Architect's Supplemental Instructions

PROJECT: *(name and address)*
Wilma P. Mankiller Health Center
Expansion
Stilwell, OK

ASI INFORMATION:
ASI Number: Bid Package 01 - ASI 004

Bid Package 01- ASI 04 – Wilma P. Mankiller Health Center Expansion

A1 FLOOR FRAMING PLAN - SECTOR 1
SCALE: 1/8" = 1'-0"

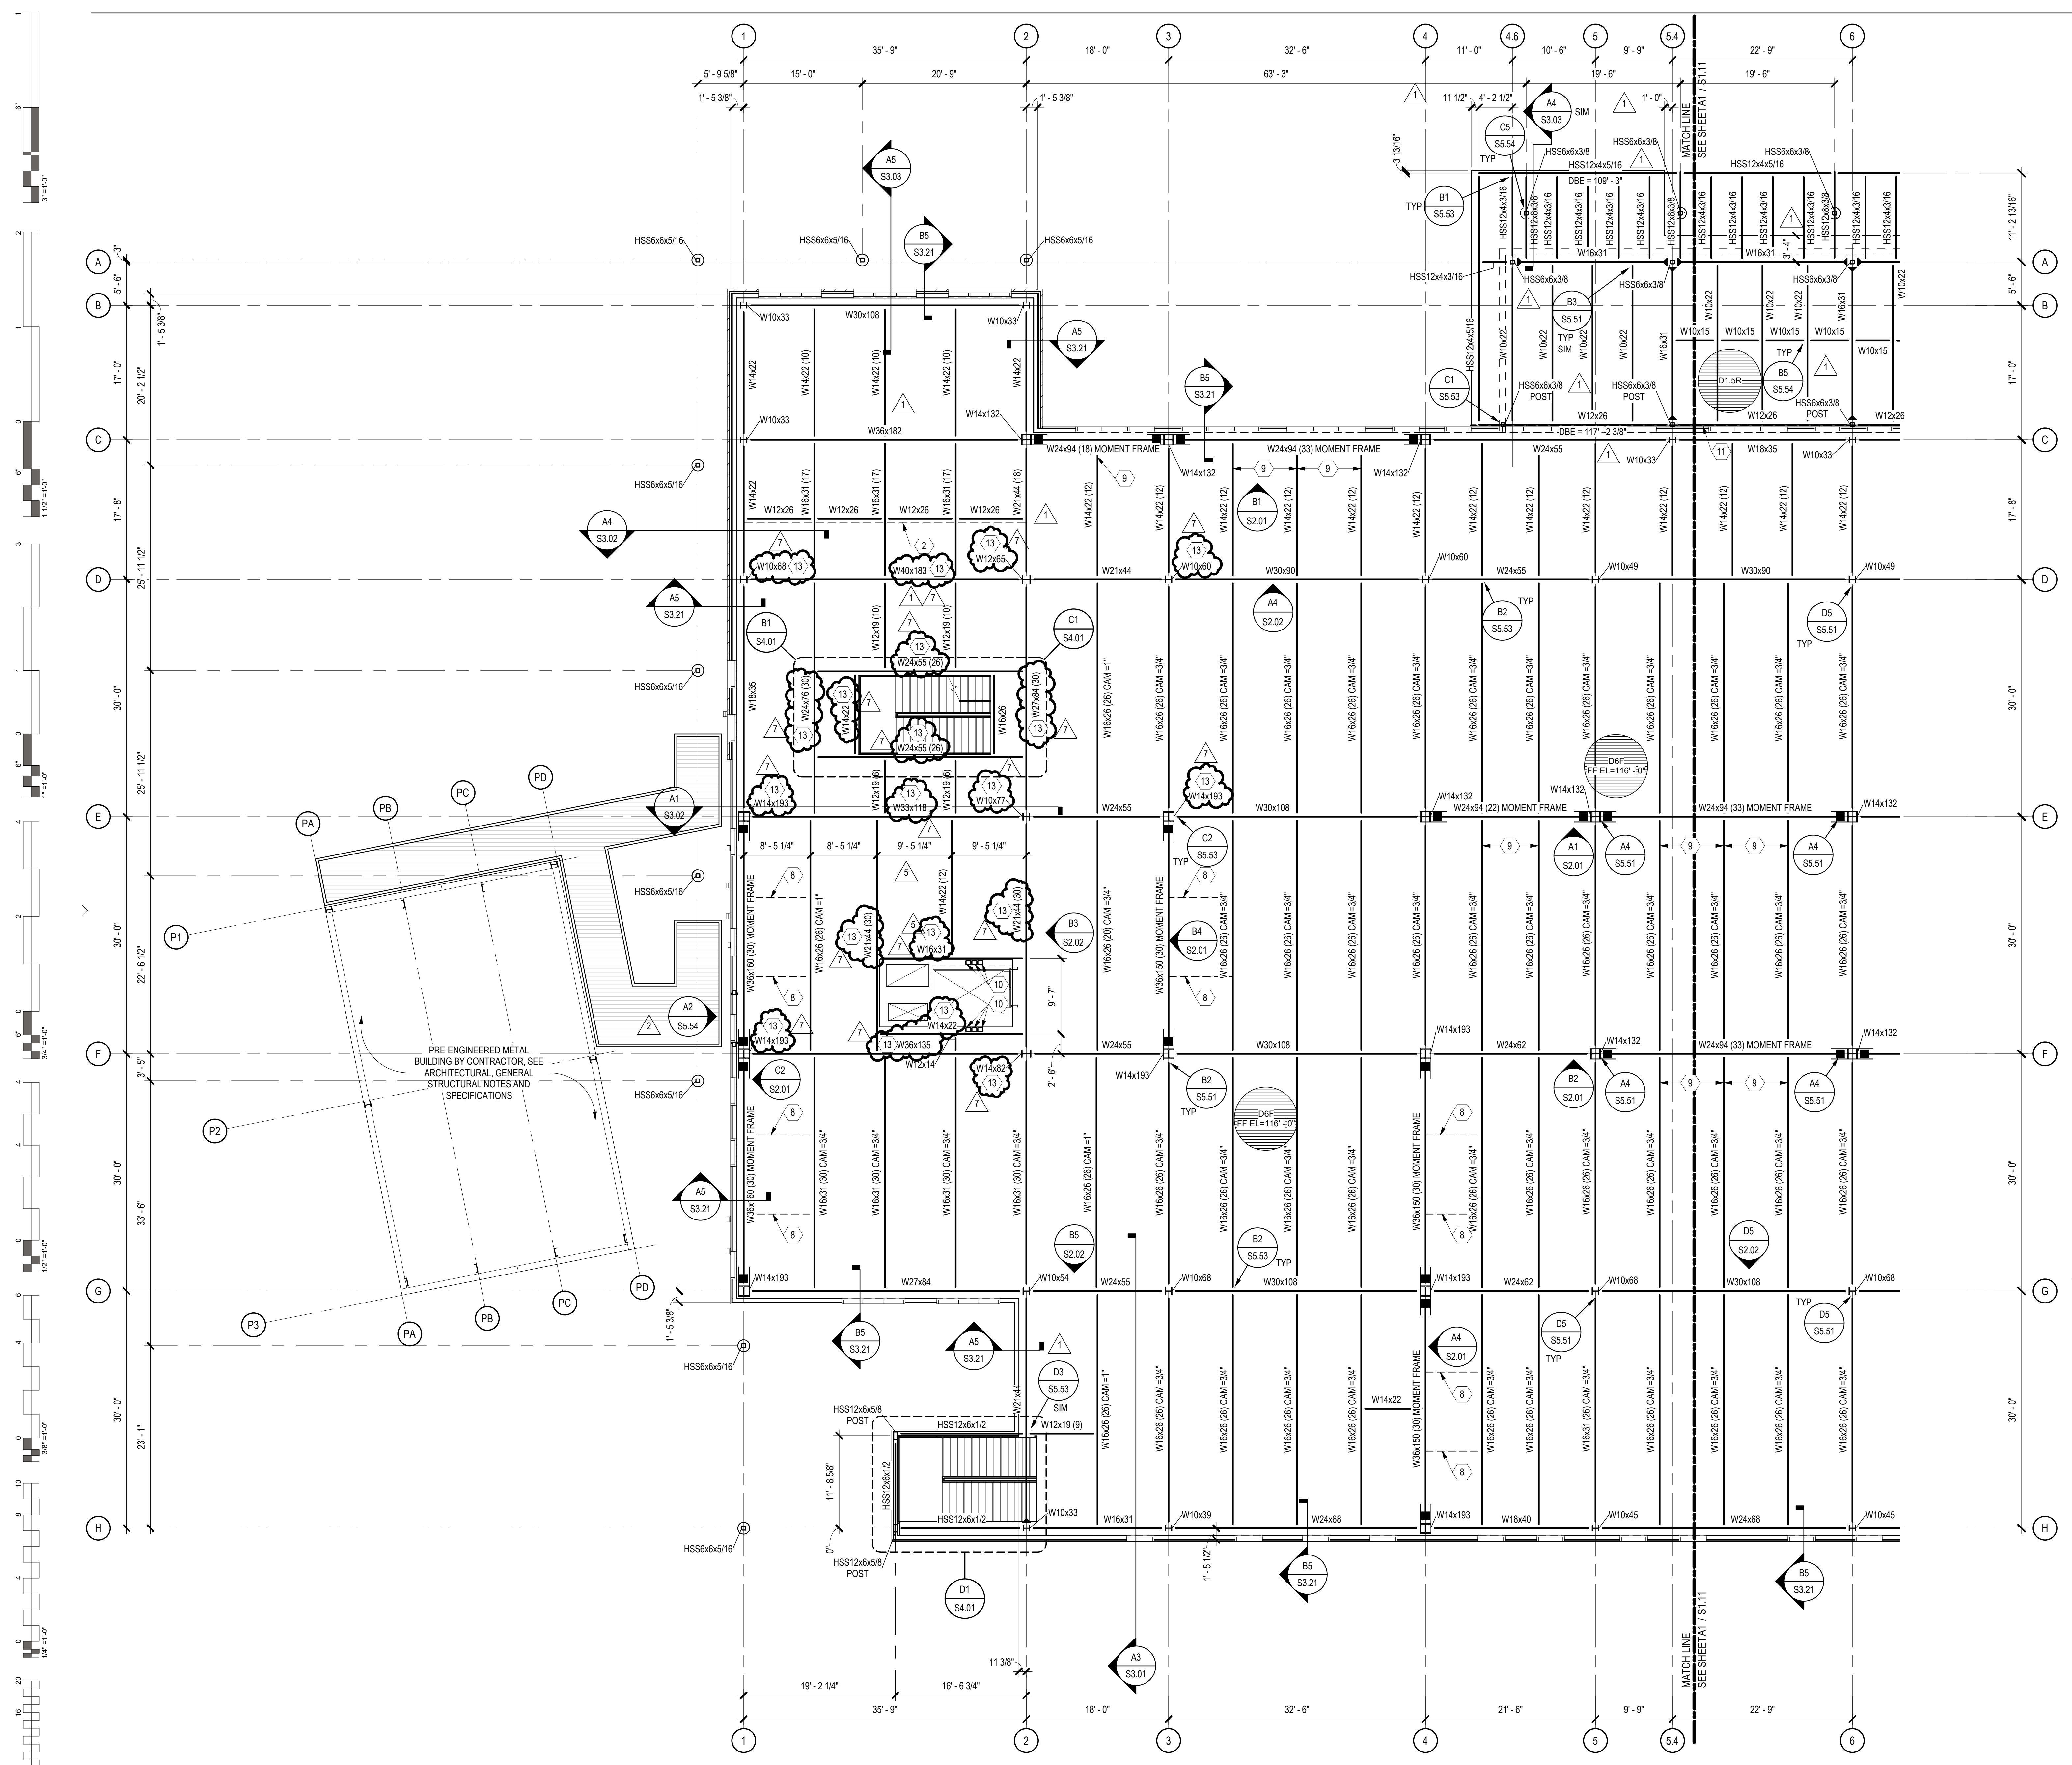
<u>Sheet</u>	<u>Description</u>
S1.01	Keynote 21, with associated plan annotations, added.
S1.02	Keynote 21, with associated plan annotations, added.
S1.11	Keynote 13, with associated plan annotations, added.
S1.12	Keynote 13, with associated plan annotations, added.
S1.13	Keynote 13, with associated plan annotations, added.
S1.21	Keynote 9, with associated plan annotations, added.
S1.22	Keynote 9, with associated plan annotations, added.

- 2" BUILDING EXPANSION JOINT. SEE ARCHITECTURAL DRAWINGS.
- SLAB EDGE TO BE LOCATED 6" FROM GRID. SEE S7.41 FOR SLAB EDGE DETAILS.
- STRUCTURAL MEMBER, INCLUDING ASSOCIATED DECK EDGE SUPPORT PER S7.21. SUPPORTING EXIT STAIRS AND/OR RATED ENCLOSURE. SEE LIFE SAFETY DRAWINGS FOR FIREPROOFING REQUIREMENTS.
